CITY OF ALBUQUERQUE

Re: Barlow Shop
6205 Wilshire Ave NE
Traffic Circulation Layout
Engineer's/Architect's Stamp 12-11-19 (C18D070)

Based upon the information provided in your submittal received 2-3-20, the above referenced plan cannot be approved for Building Permit until the following comments are addressed:

Site Plan

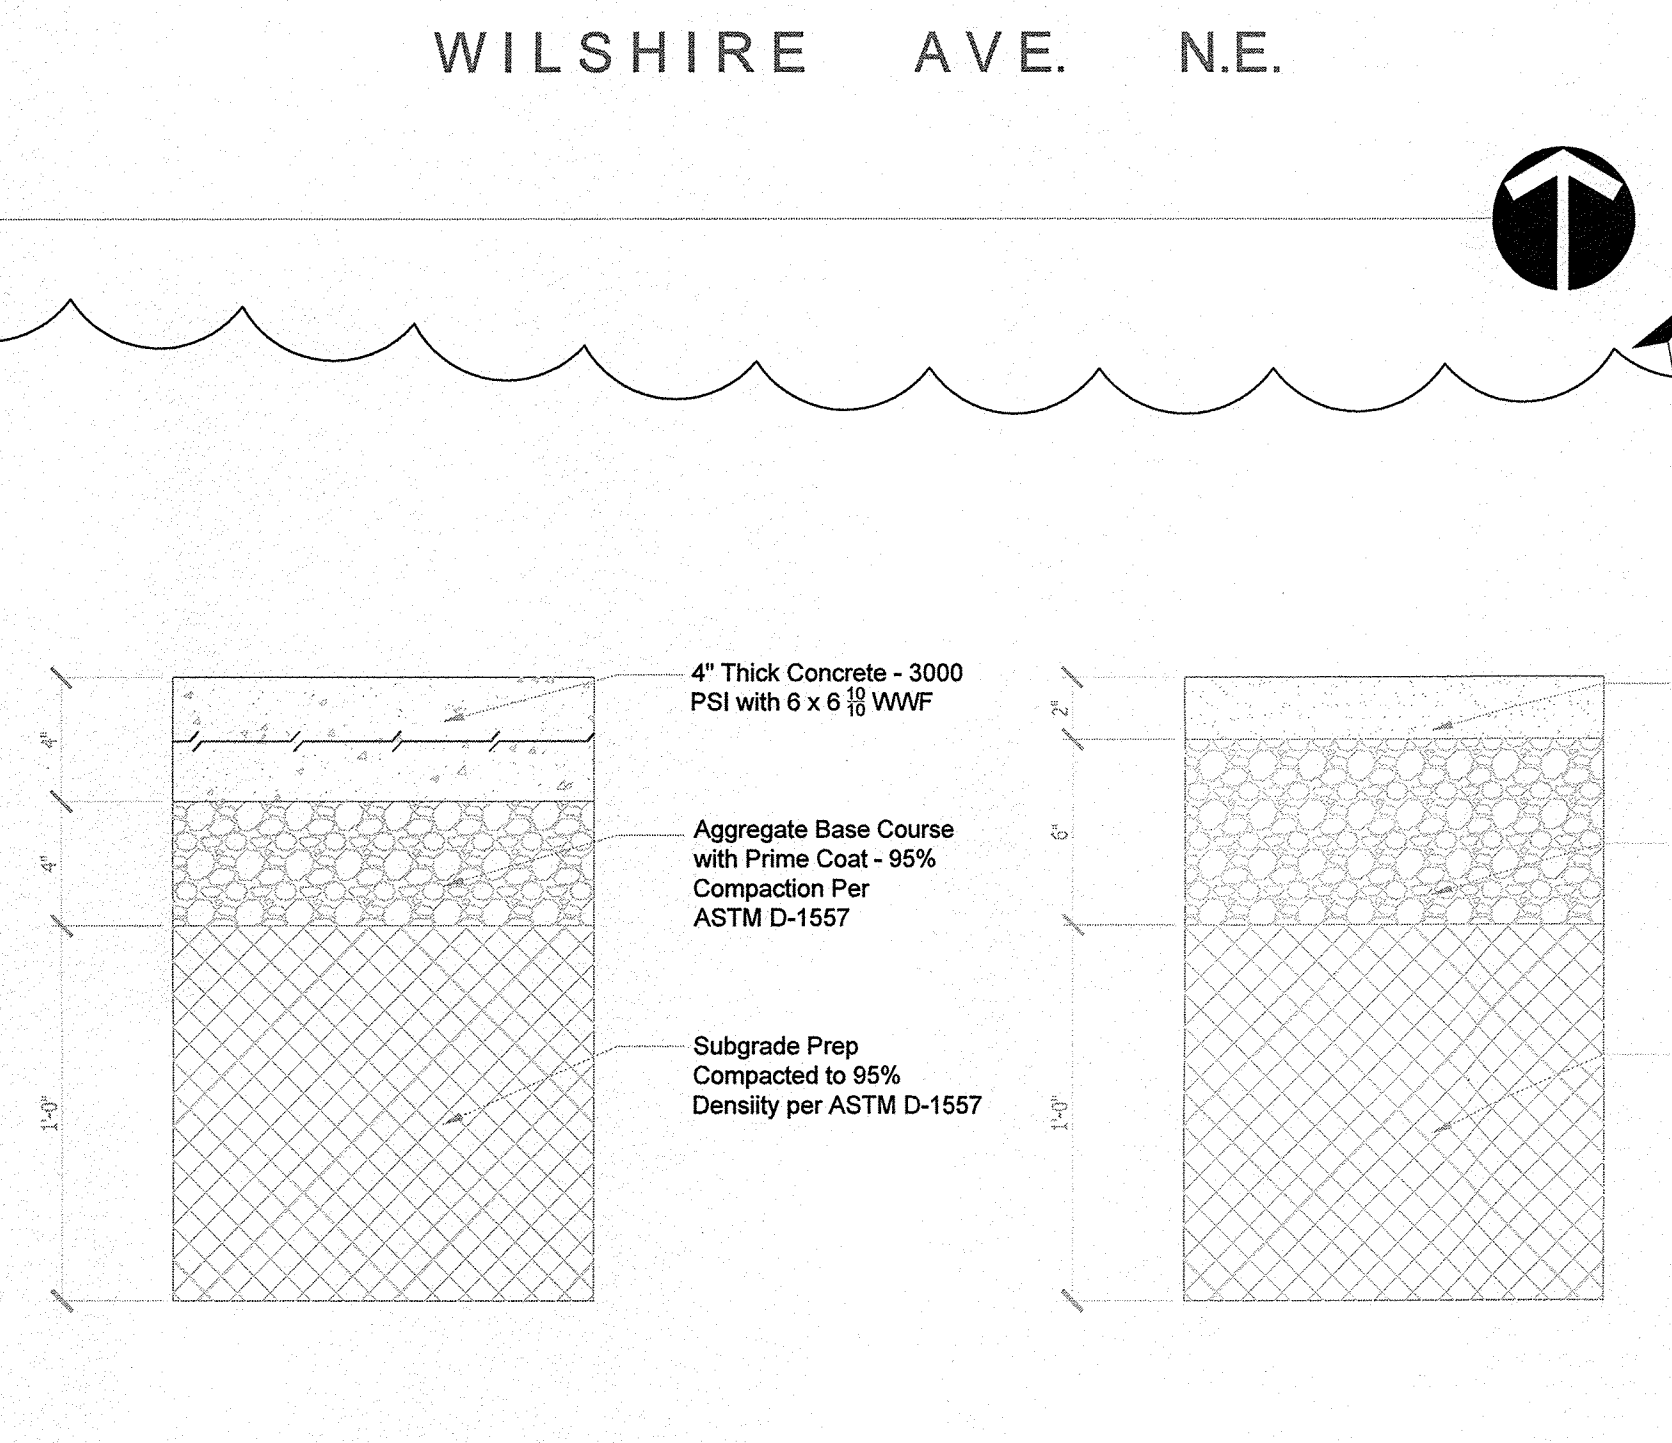
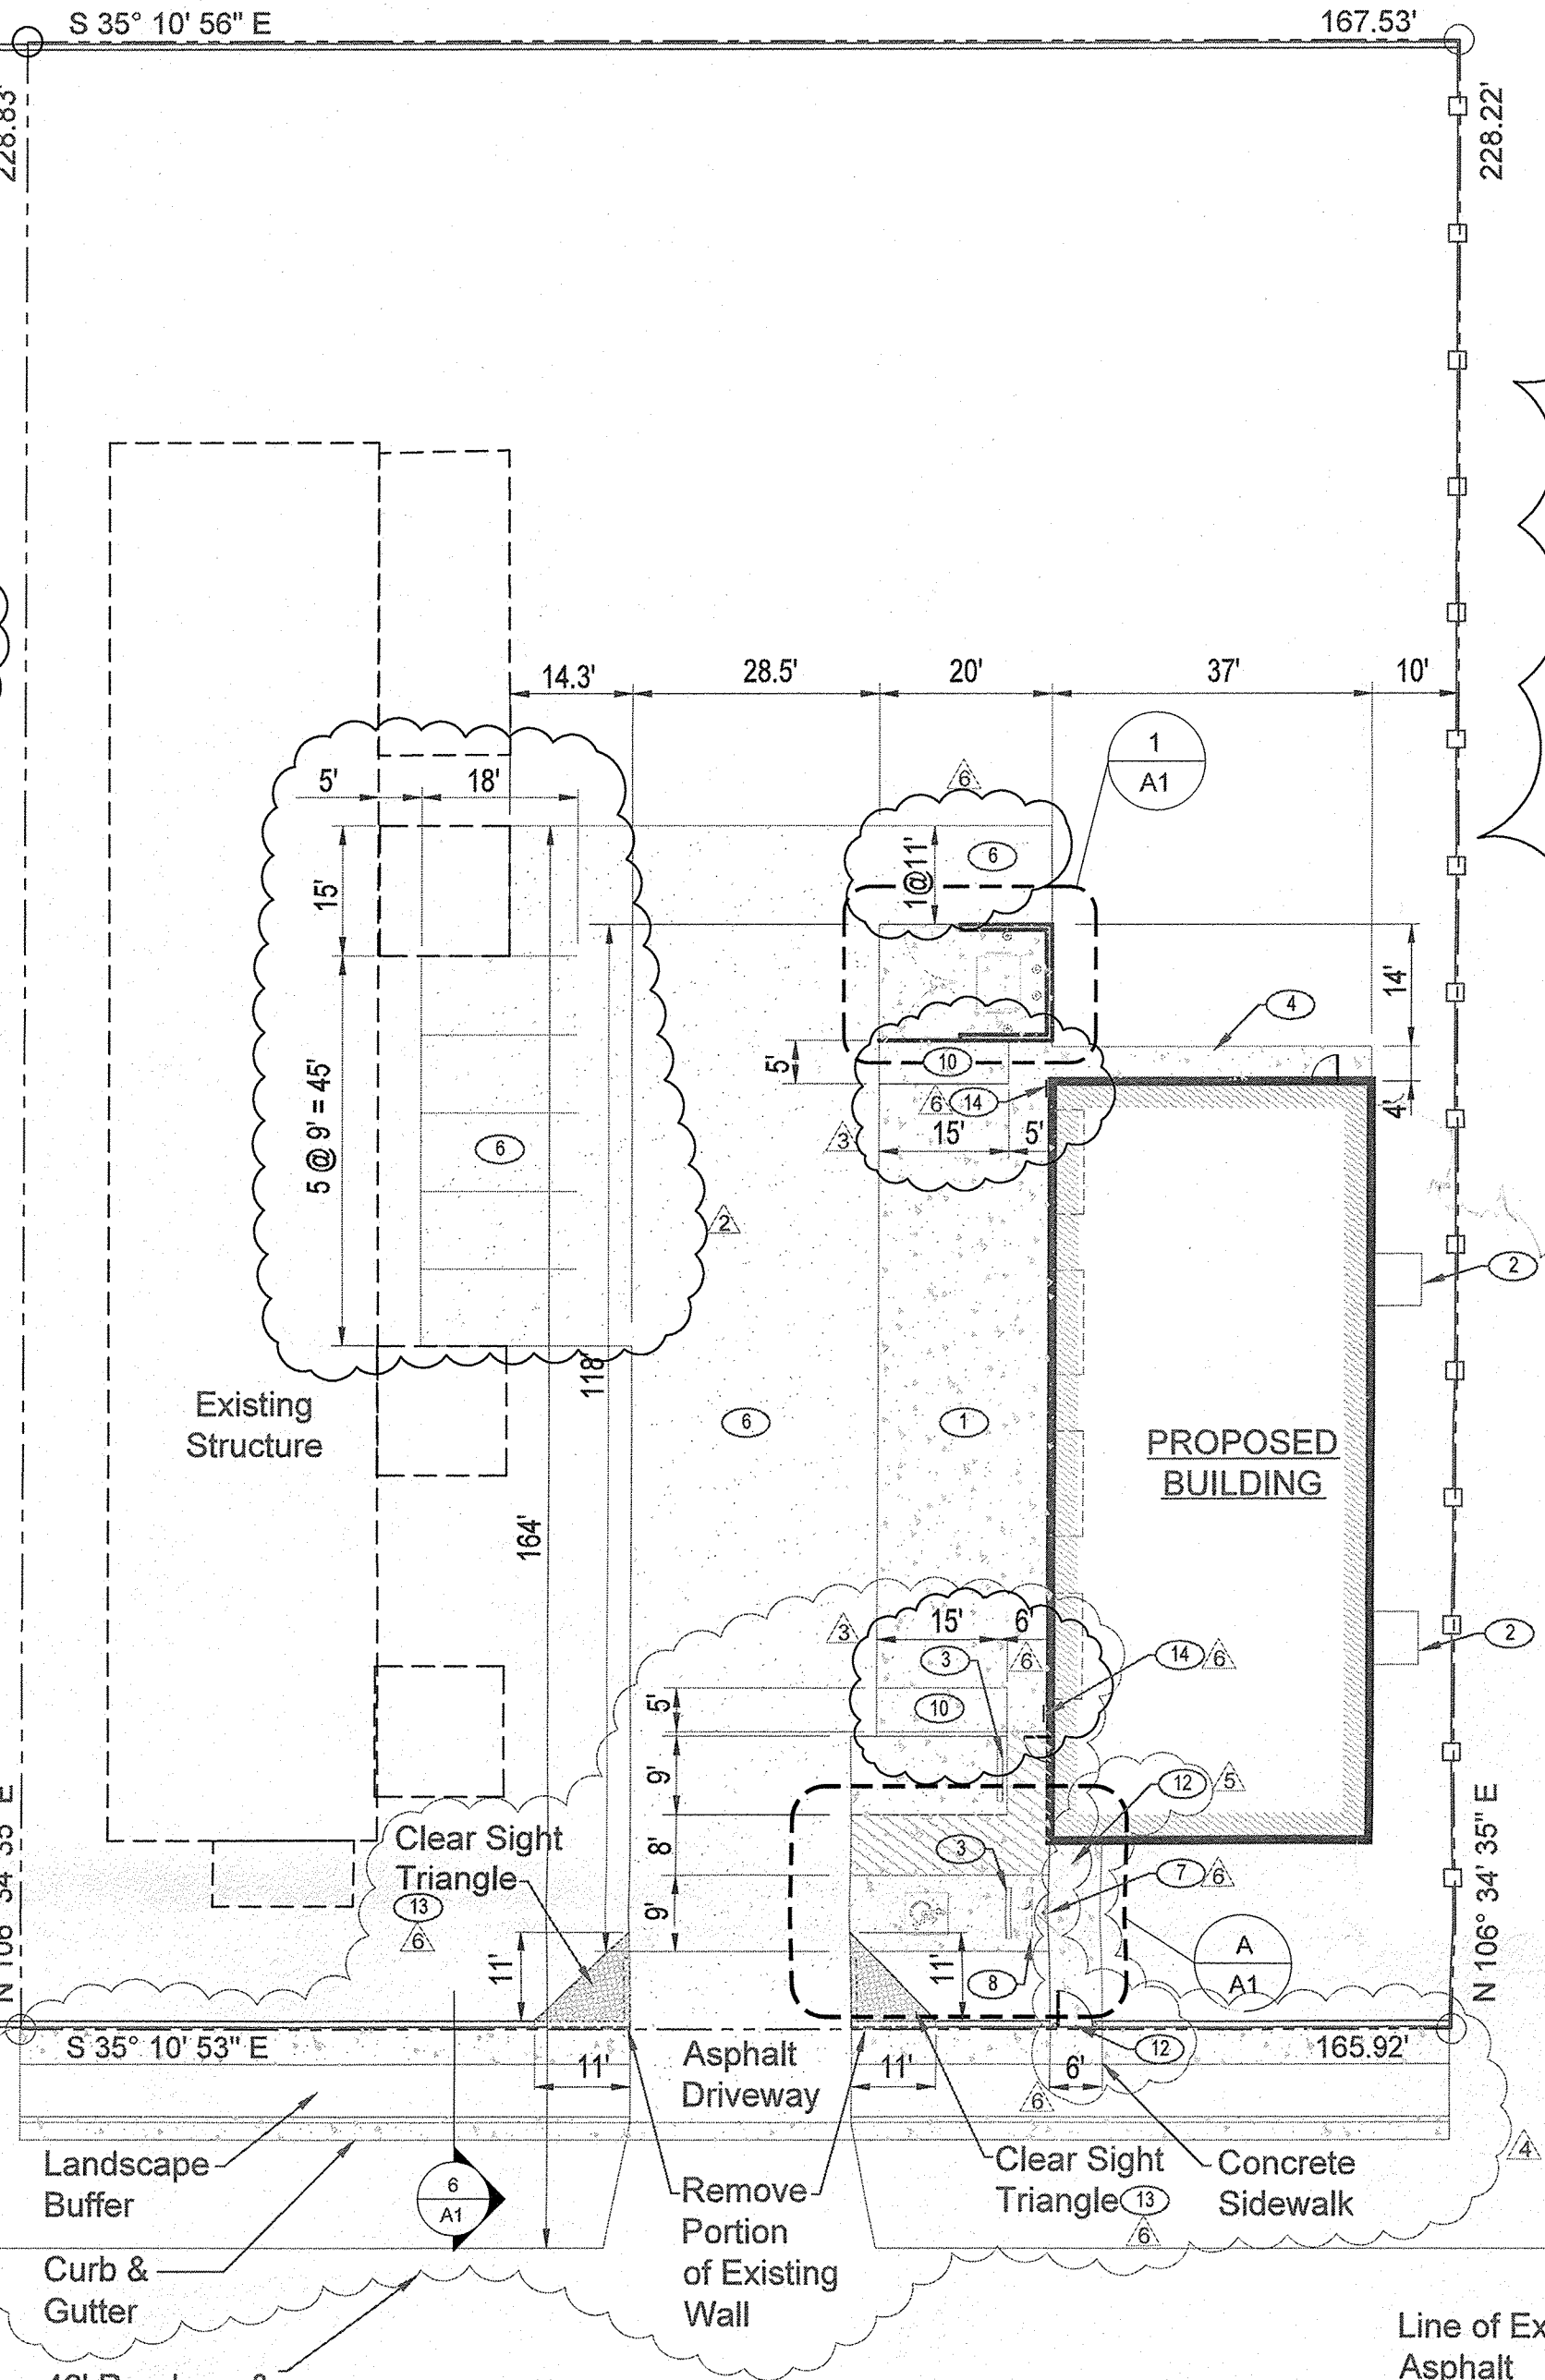
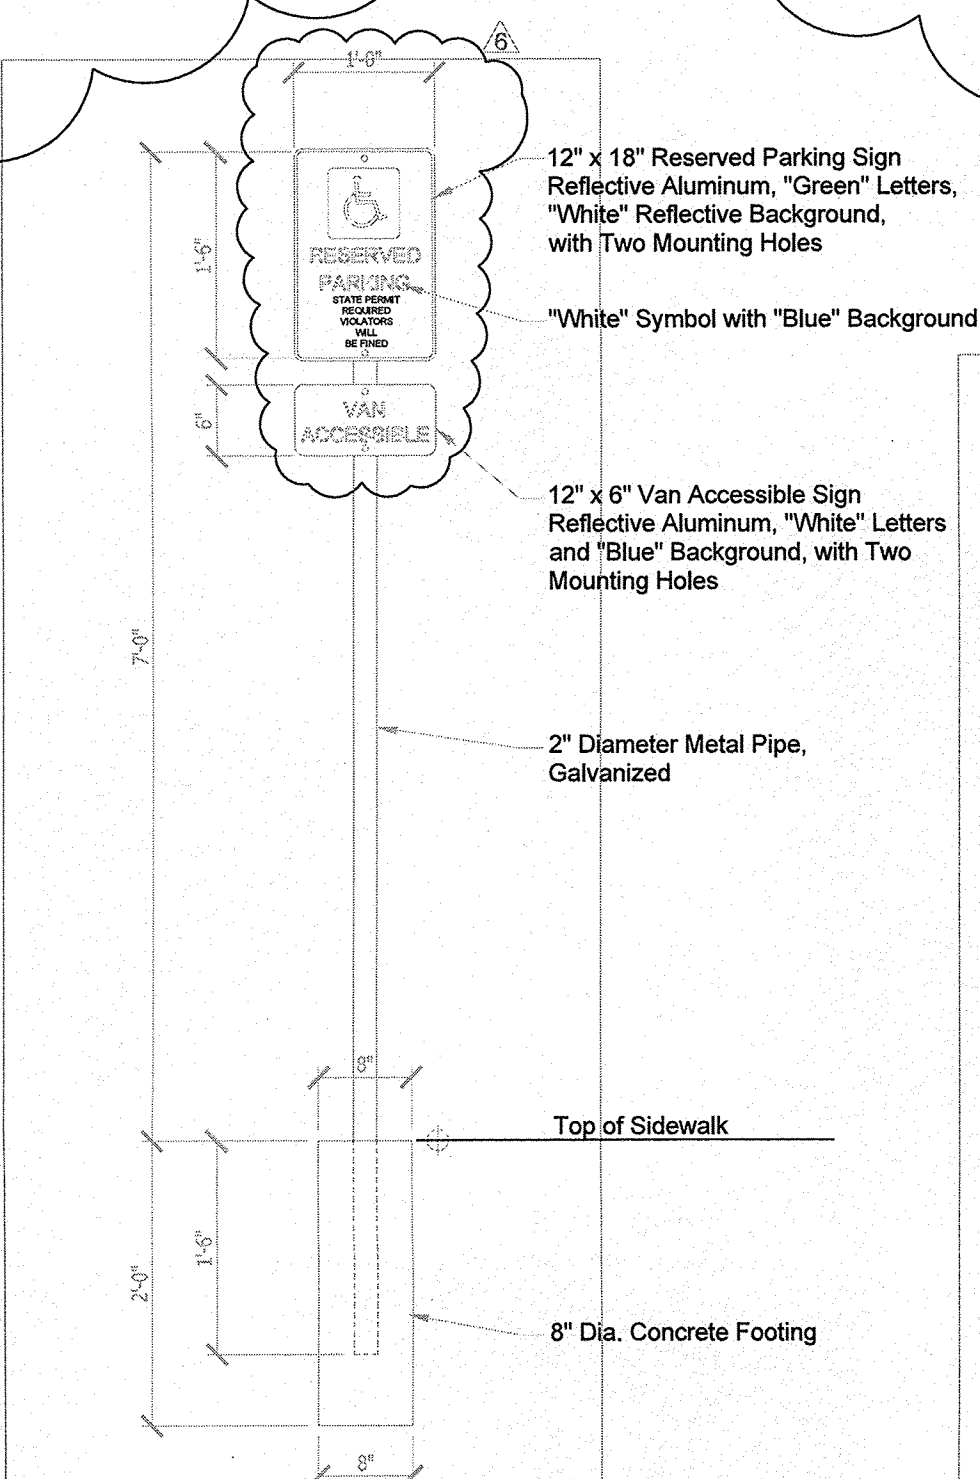
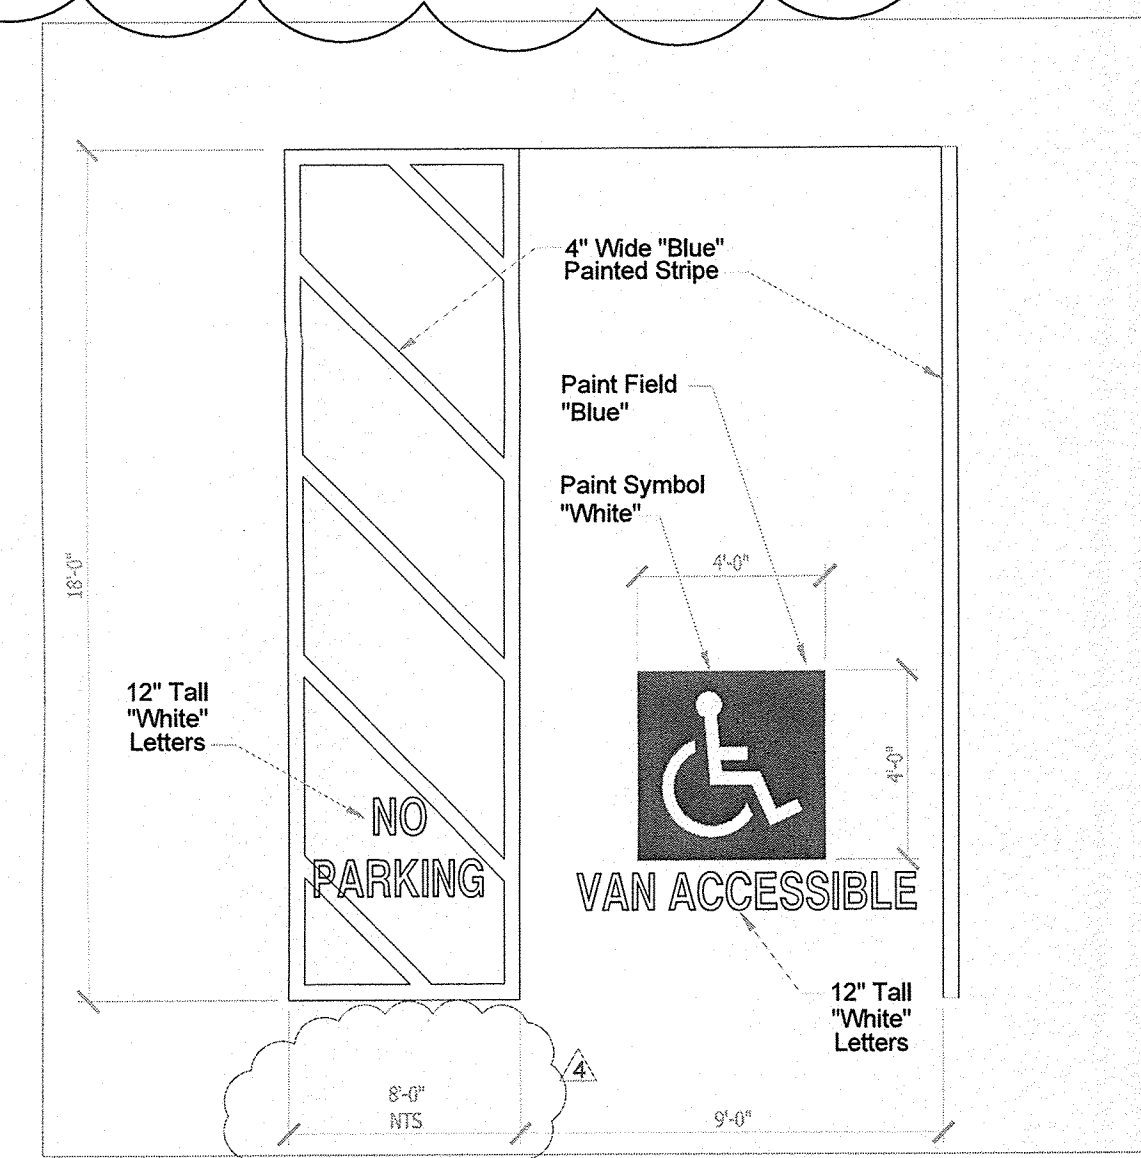
1. Please remove clouds on TCL Plan.
2. Please relocate Bike Rack, not allowed within parking stall.
3. All bicycle racks shall be designed according to the following guidelines:

- a. The rack shall be a minimum 30 inches tall and 18 inches wide.
 - b. The bicycle frame shall be supported horizontally at two or more places. Comb/toaster racks are not allowed.

- c. The rack shall be designed to support the bicycle in an upright position. See the IDO for additional information.
 - d. The rack allows varying bicycle frame sizes and styles to be attached.

- e. The user is not required to lift the bicycle onto the bicycle rack.
 - f. Each bicycle parking space is accessible without moving another bicycle.

4. Bicycle racks shall be sturdy and anchored to a concrete pad.
5. A 1-foot clear zone around the bicycle parking stall shall be provided.
6. Bicycle parking spaces shall be at least 6 feet long and 2 feet wide.

Once corrections are complete please deliver TCL to front counter. No Resubmittal required. Minor Corrections.
